GWP Job Reference	(557)2405
Job Title	Healey Lane, Batley
Client	MTSPV / Connect Homes

<b>Proposed Boundary Treatments</b>	
Name	2405-GWP-00-00-D-A-(00)-0025
Scale	1:500@A3
Revision	C06
Drawn/Checked	MK / DT
First Issue	27.06.25
Drawing Status	Technical Design - A04

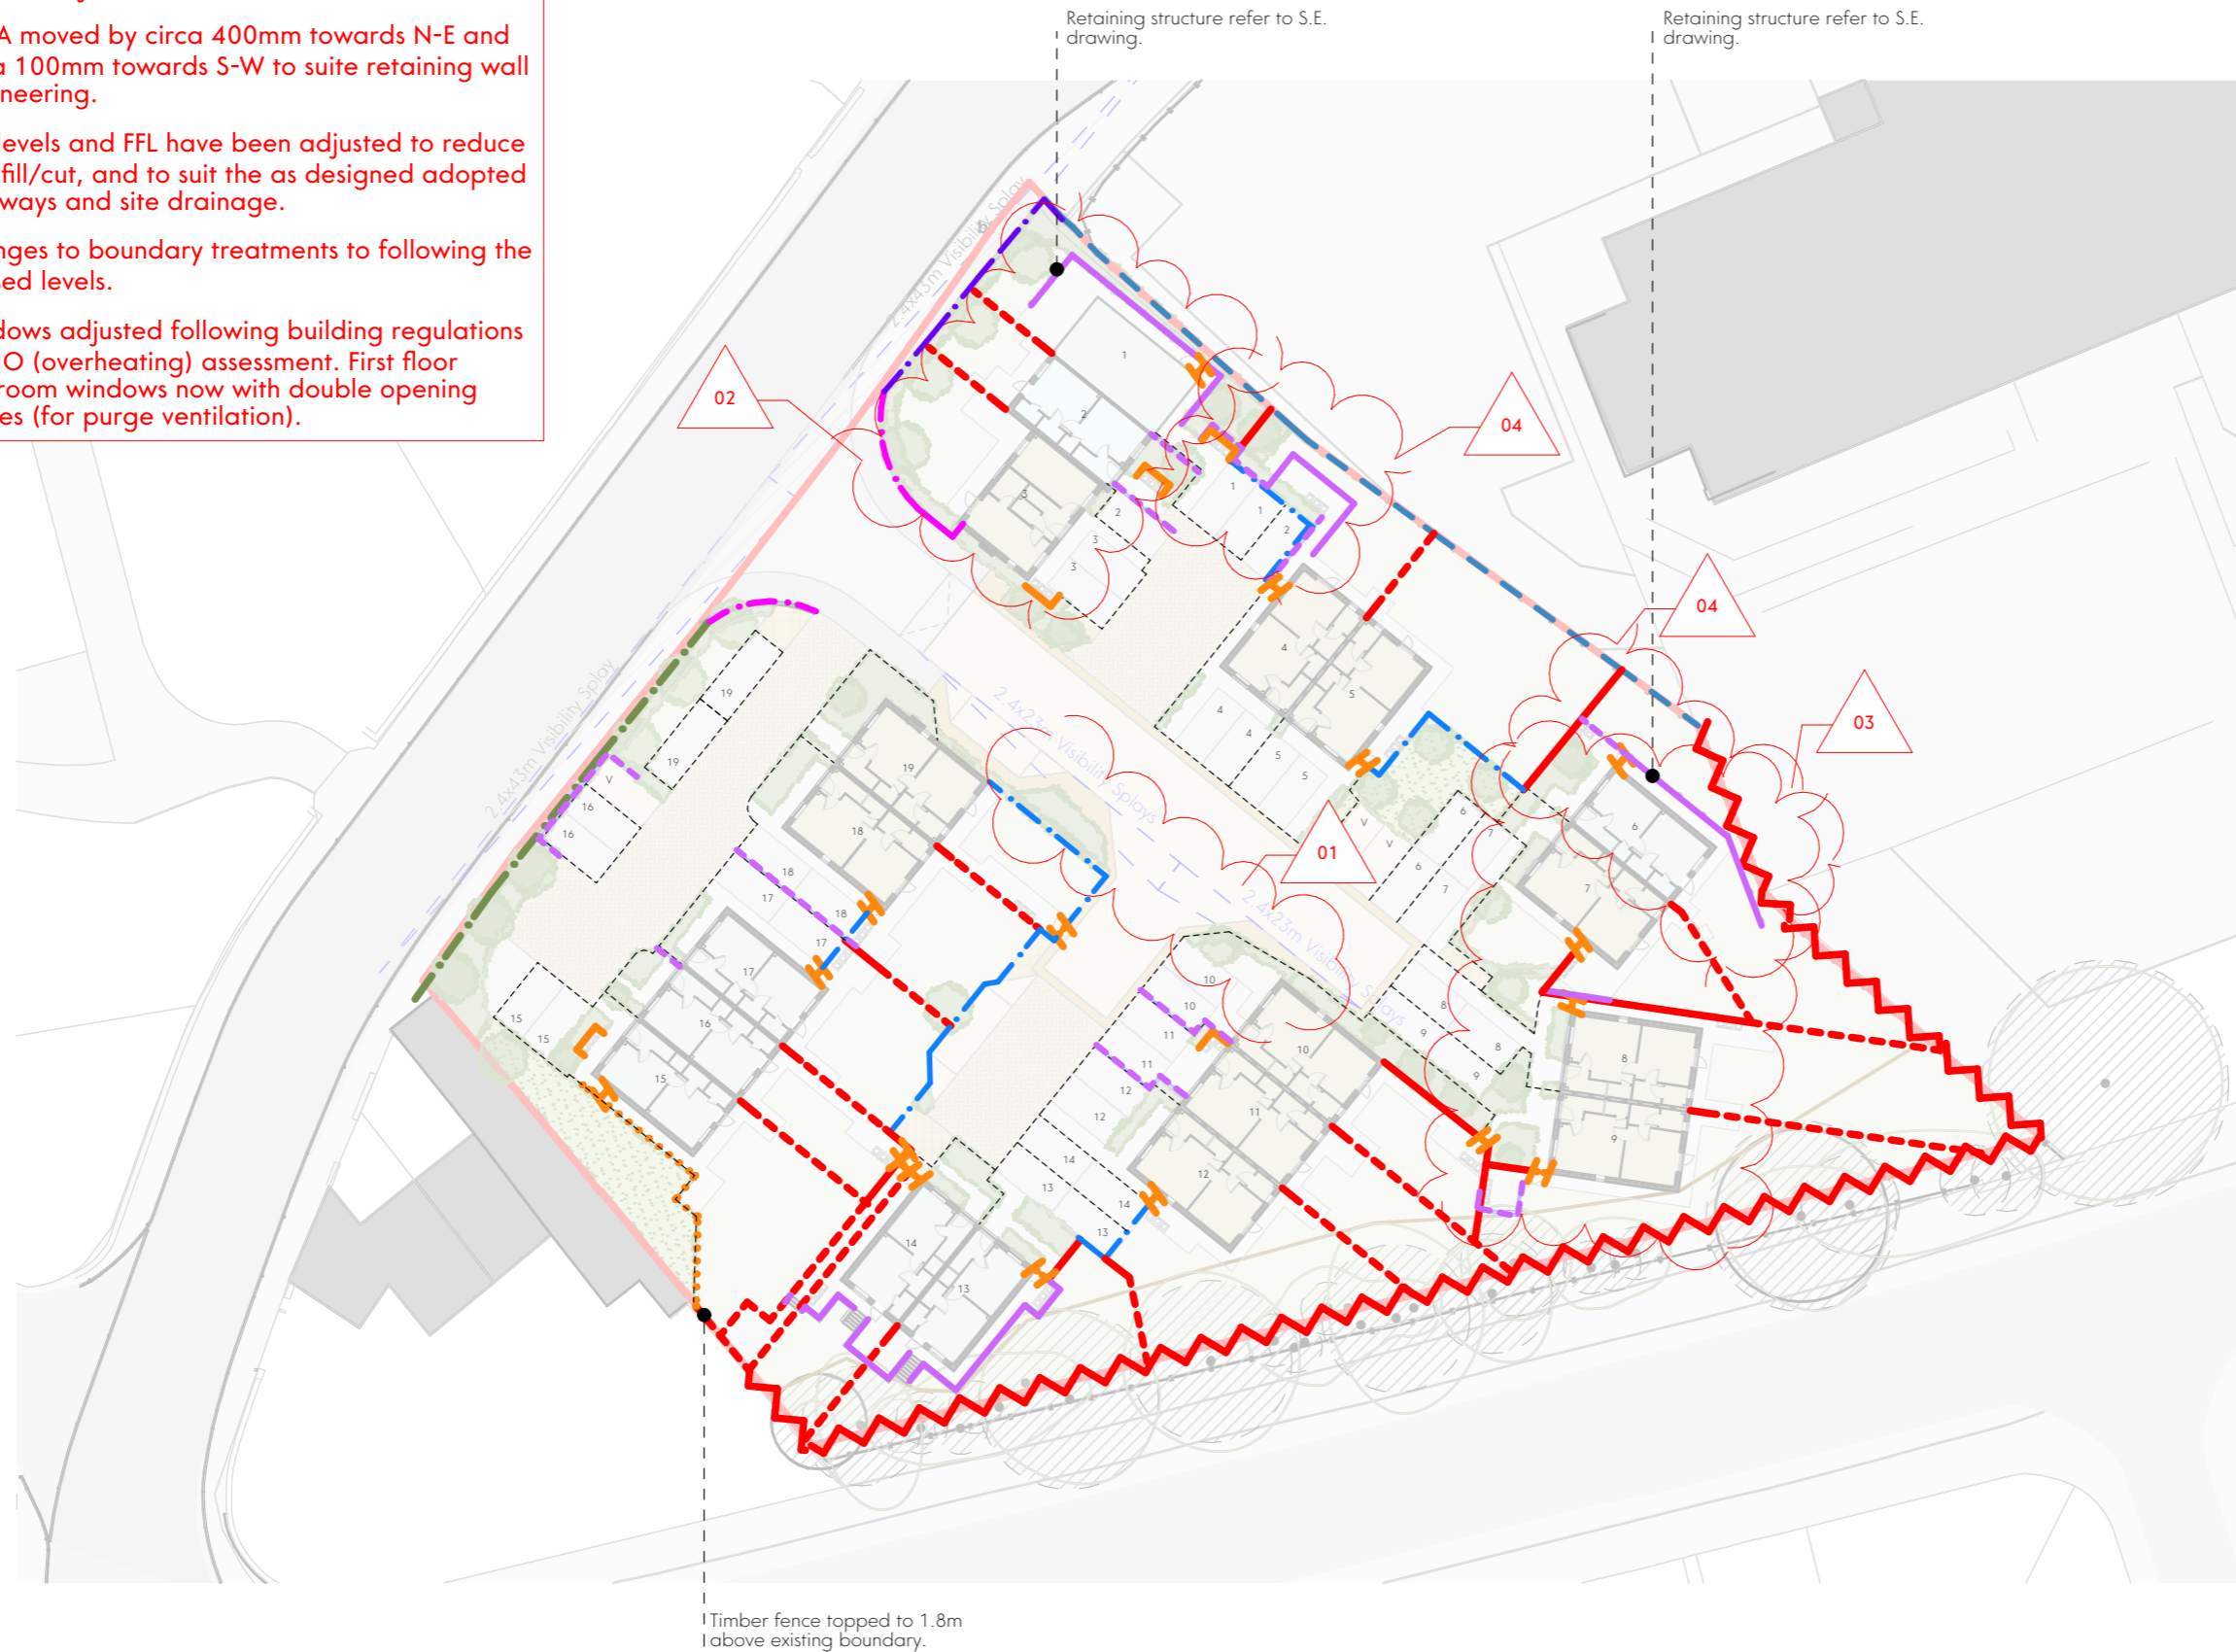
- 01. Internal road layout revised to suite highway sectional approval (visibility splays to central junction adjusted).
- 02. Plot A moved by circa 400mm towards N-E and circa 100mm towards S-W to suite retaining wall engineering.
- 03. Site levels and FFL have been adjusted to reduce landfill/cut, and to suit the as designed adopted highways and site drainage.
- 04. Changes to boundary treatments to following the revised levels.
- 05. Windows adjusted following building regulations Part O (overheating) assessment. First floor bedroom windows now with double opening sashes (for purge ventilation).

C06	03.12.25	Issue as S73.	CT	DT
C05	27.11.25	Type F description update	CT	DT
		Update to flag on edge		
C04	17.11.25	location	CT	DT
C03	13.10.25	Update to visibility splays	CT	DT
C02	31.07.25	General Update	CT	DT
C01	27.06.25	First Issue	MK	DT
Rev	Date	Comment	Dr	Ch
B:\McCloud_NewBuild\Server - BIMcloud Basic for Archcad 28\Healey Lane - (557)2405 - GWP-XX-ZZ-W3-A-WTSPV-P08
